ADDENDUM NO. 1

**Citywide Adaptive Signal Control System – ITS Improvements – Phase 1 & 2 and Phase 3
RFB # 19-011**

ITS04

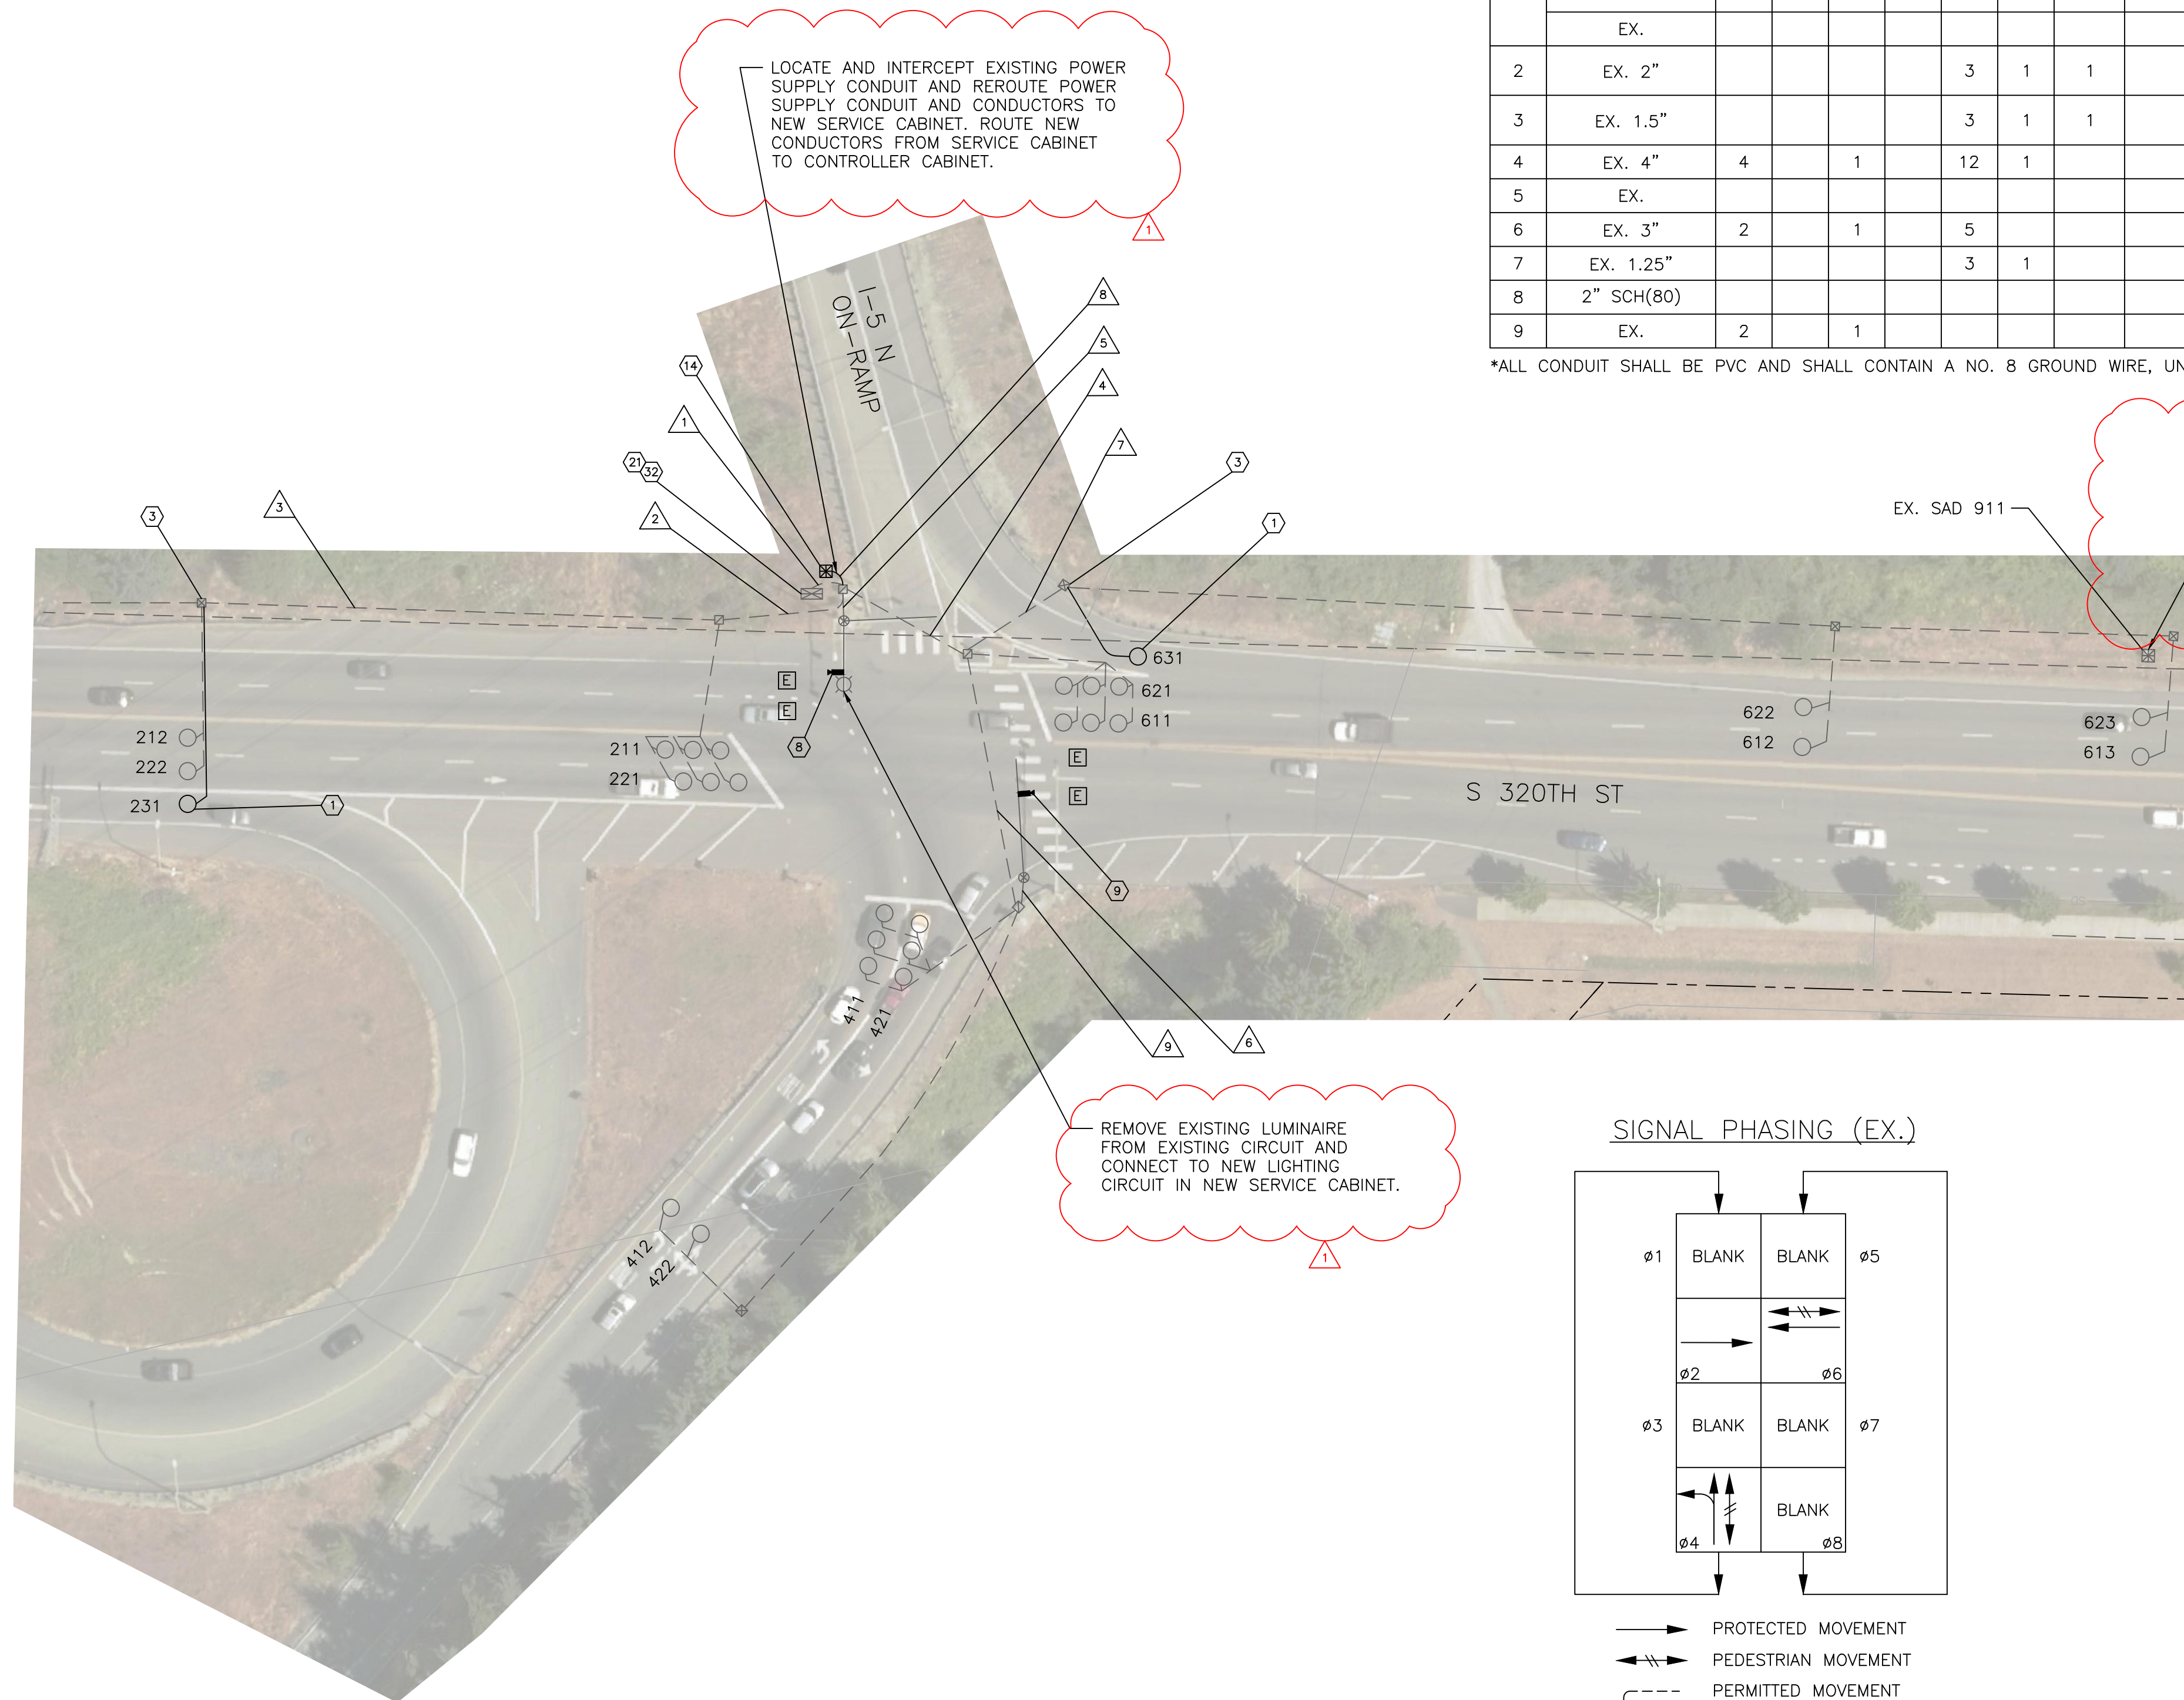
DELETE this sheet and REPLACE with the attached revised Sheet ITS04.

This change provides additional details regarding the installation of the new electrical service cabinet to serve the traffic signal system and intersection lighting on the signal poles.

- ⑭ INSTALL SERVICE CABINET AND FOUNDATION PER CITY FEDERAL WAY STANDARD DRAWING 3-45. RE-ROUTE EXISTING SIGNAL SERVICE CONDUCTORS TO NEW SERVICE CABINET. IF EXISTING SIGNAL SERVICE CONDUCTORS NEED TO BE LENGTHENED, NEW CONDUCTORS SHALL BE USED. COORDINATE USE OF EXISTING POWER SUPPLY WITH PUGET SOUND ENERGY.

ITS42
SHEET 29 OF 69 SHEETS

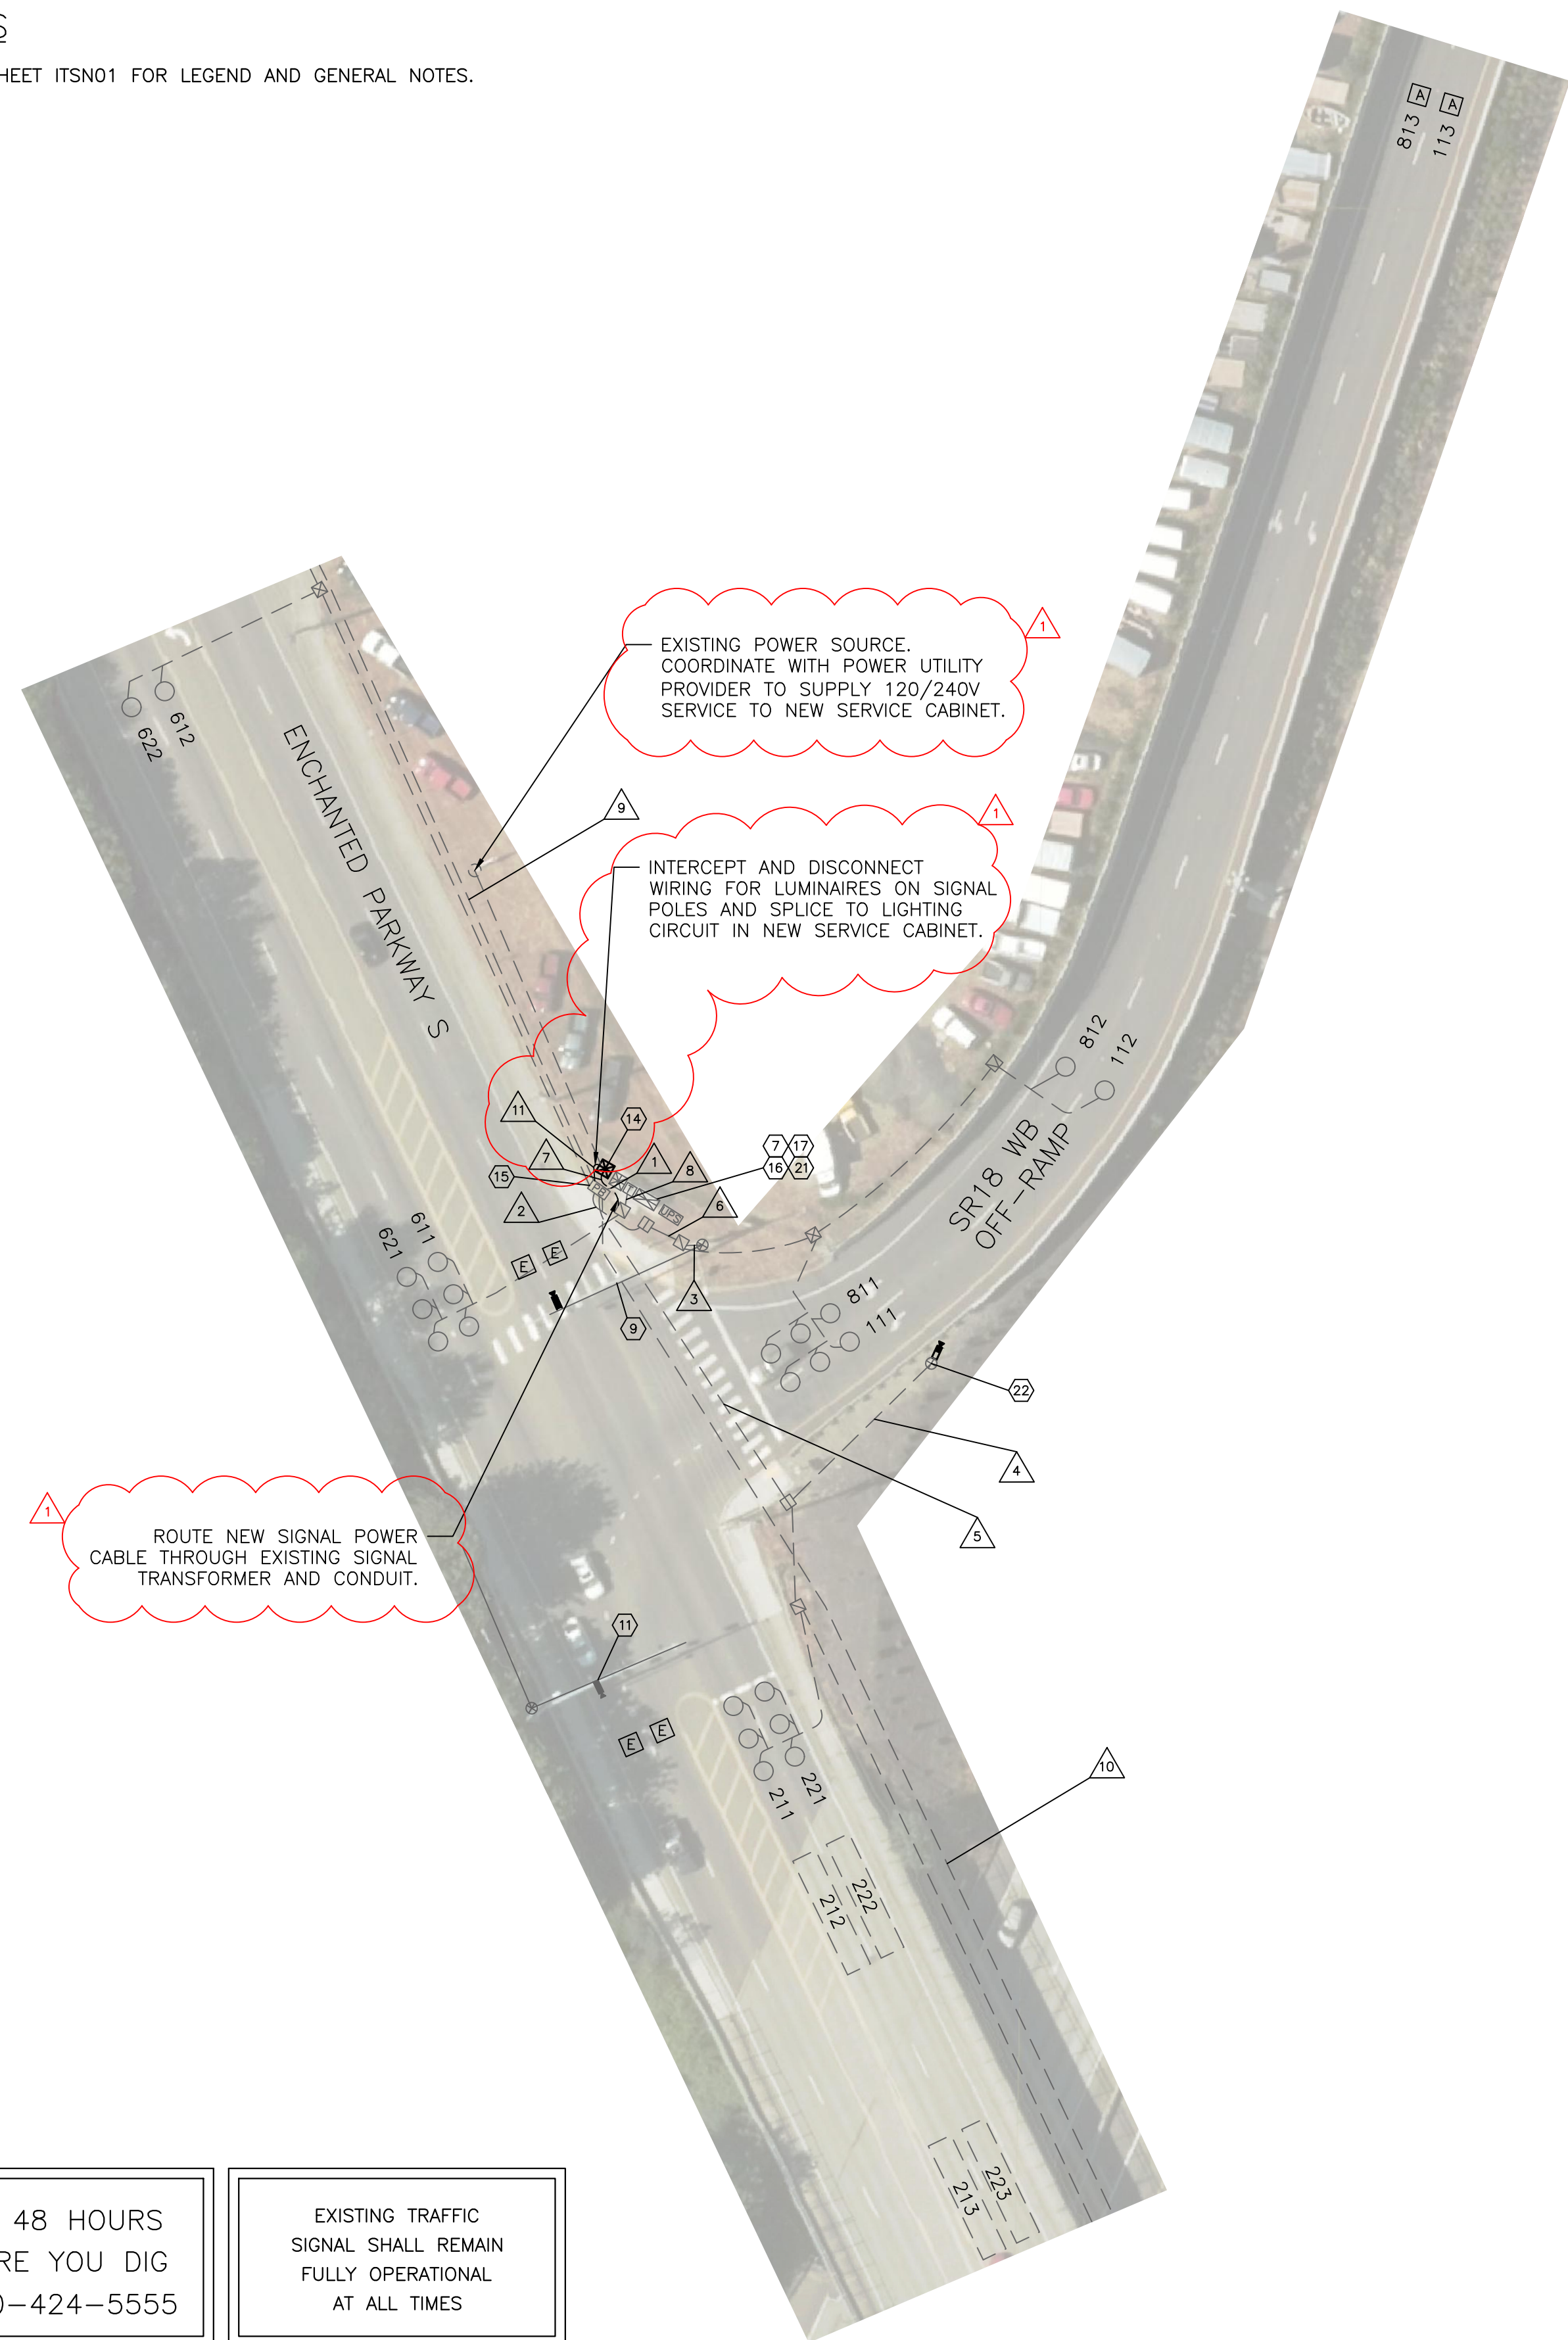
DELETE this sheet and REPLACE with the attached revised Sheet ITS42.

This change provides additional details regarding the installation of the new electrical service cabinet to serve the traffic signal system and intersection lighting on the signal poles.

ITS43
SHEET 30 OF 69 SHEETS

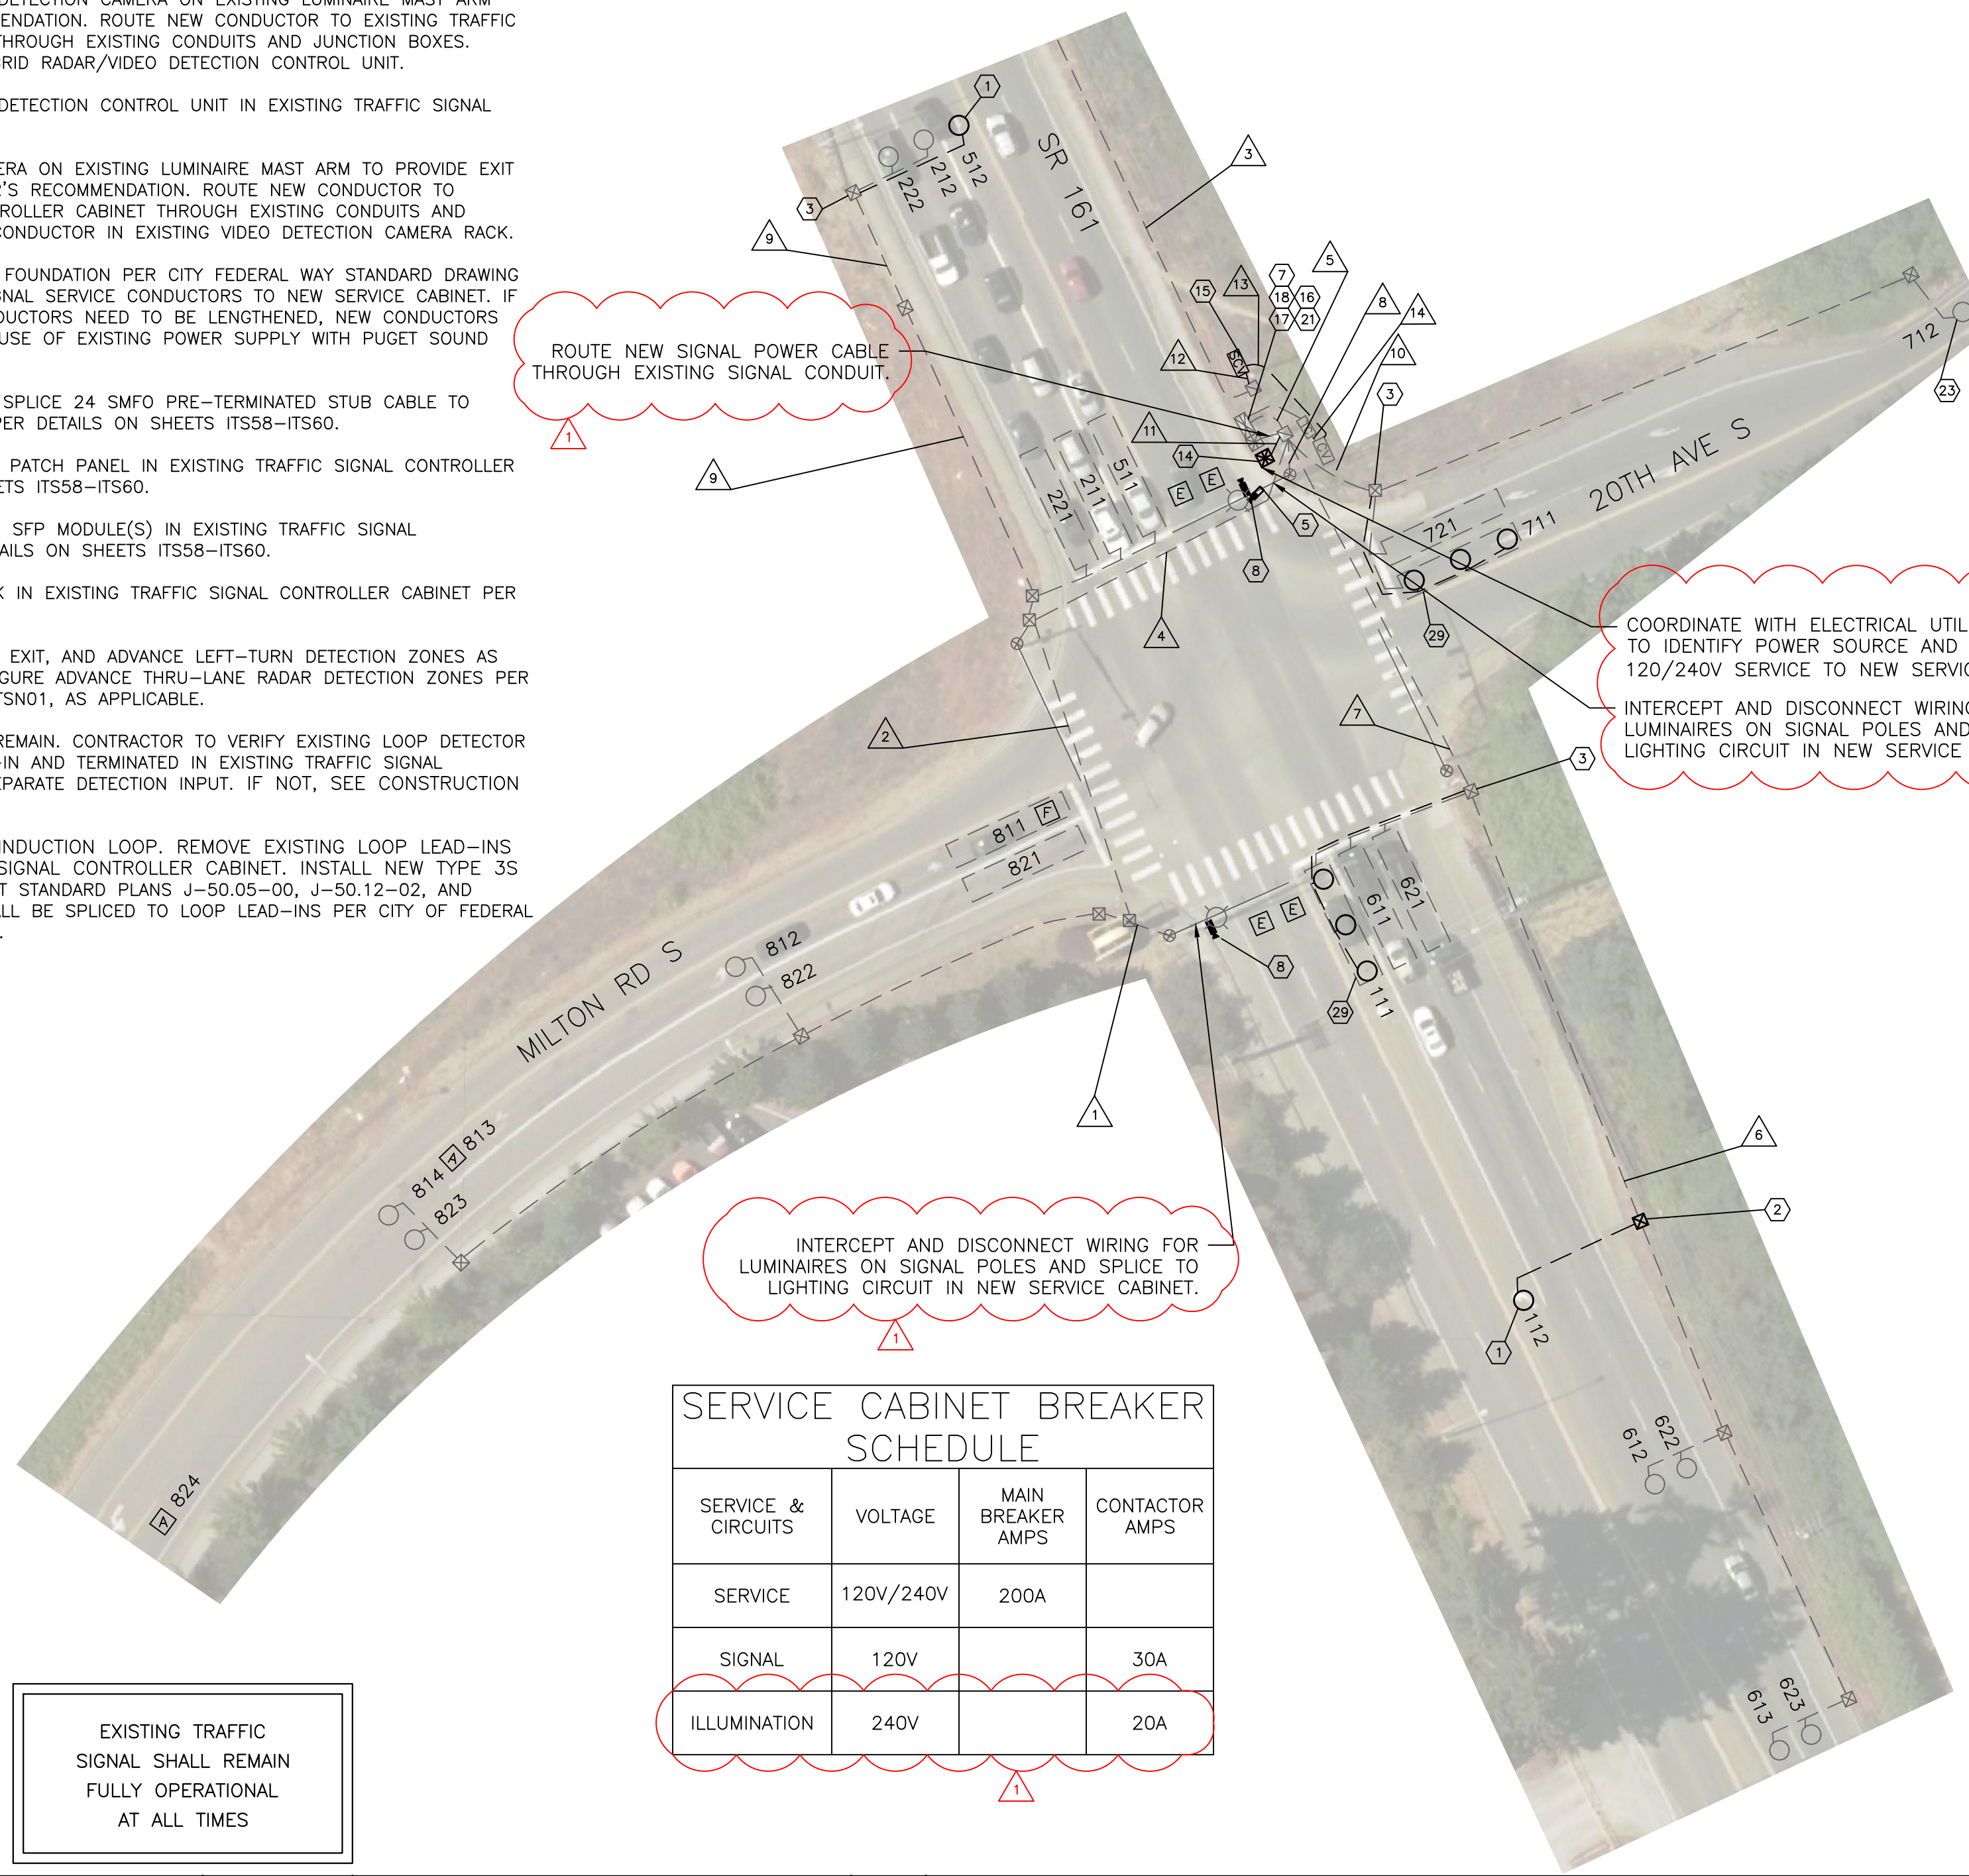
DELETE this sheet and REPLACE with the attached revised Sheet ITS43.

This change provides additional details regarding the installation of the new electrical service cabinet to serve the traffic signal system and intersection lighting on the signal poles.

- ⑭ INSTALL SERVICE CABINET AND FOUNDATION PER CITY FEDERAL WAY STANDARD DRAWING 3-45. RE-ROUTE EXISTING SIGNAL SERVICE CONDUCTORS TO NEW SERVICE CABINET. IF EXISTING SIGNAL SERVICE CONDUCTORS NEED TO BE LENGTHENED, NEW CONDUCTORS SHALL BE USED. COORDINATE USE OF EXISTING POWER SUPPLY WITH PUGET SOUND ENERGY.
